APPROVALS	DATE	TITLE		
DRAWN <i>Kylie Esaw</i>	5-16-02	<b>SERVICE BULLETIN, WSB C-5000-11 FIXES UNSQUELCH FOR MAIN CHANNEL RECEIVER</b>		
CHECKED <i>Clayton C. Eaton</i>	5-16-02	SIZE	CAGE CODE	DWG. NO.
ENGINEER <i>Stan Wilk</i>	5-16-02	A	1B7G3	150-041428
ISSUED <i>V. Wallace</i>	05/16/02	SCALE NONE		
				REV <b>A</b>

# SERVICE BULLETIN

**EQUIPMENT** C-5000

**BULLETIN NUMBER** WSB C-5000-11 Revision A

**FIGURE 1. UVPROM Locations, CPU board**

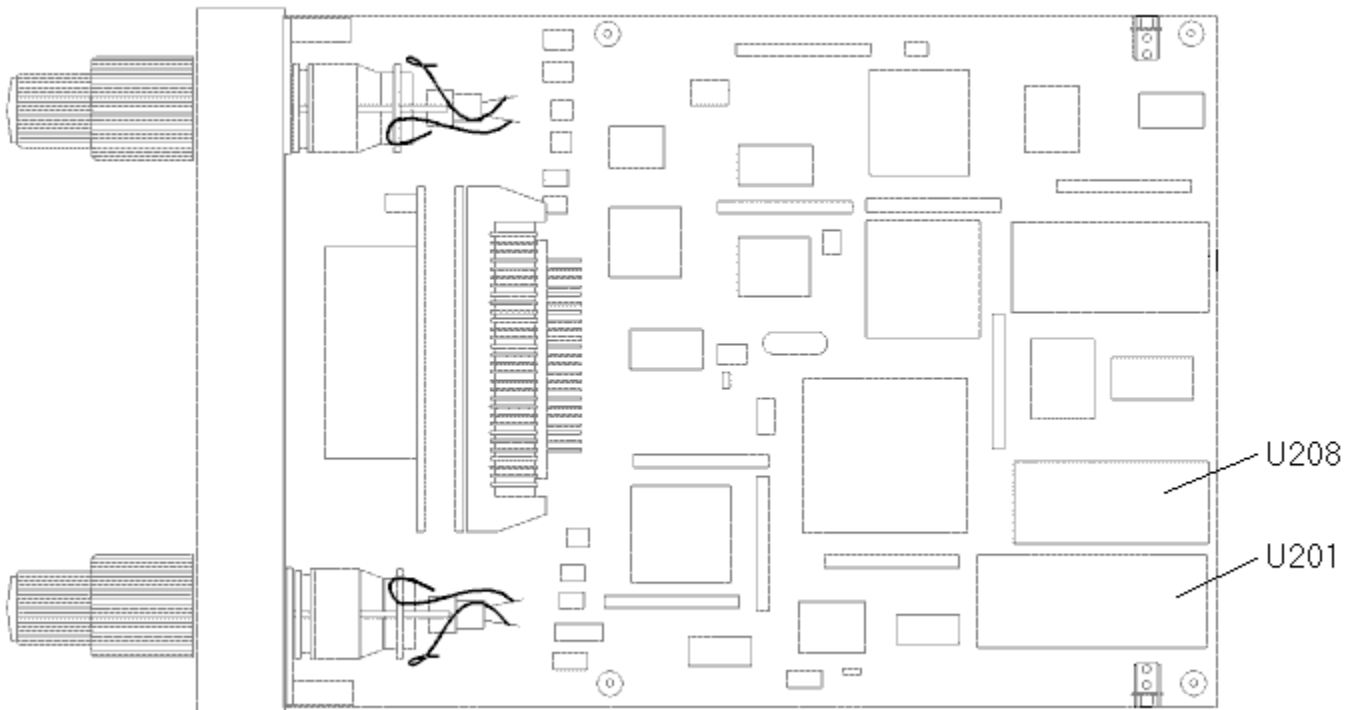
RT-5000 would not unsquelch when receiving a main channel. A variable (OTAR bits) was not being initialized properly.

1. Remove the cover from the C-5000 chassis.
2. Remove UVPROM's: U201 (P/N 106-841141-XX)  
U208 (P/N 106-841143-XX)  
from the CPU board 300-017305-01XX (see Figure 1).
3. Install updated UVPOM's: U201 (P/N 106-841141-03)  
U208 (P/N 106-841143-03)  
onto the CPU board (P/N 300-017305-01XX).
4. Reinstall the cover on the C-5000.
5. Remove existing software MOD label.
6. Mark new software MOD label (P/N 156-017926-03) with 03.
7. Affix new software MOD 03 label.
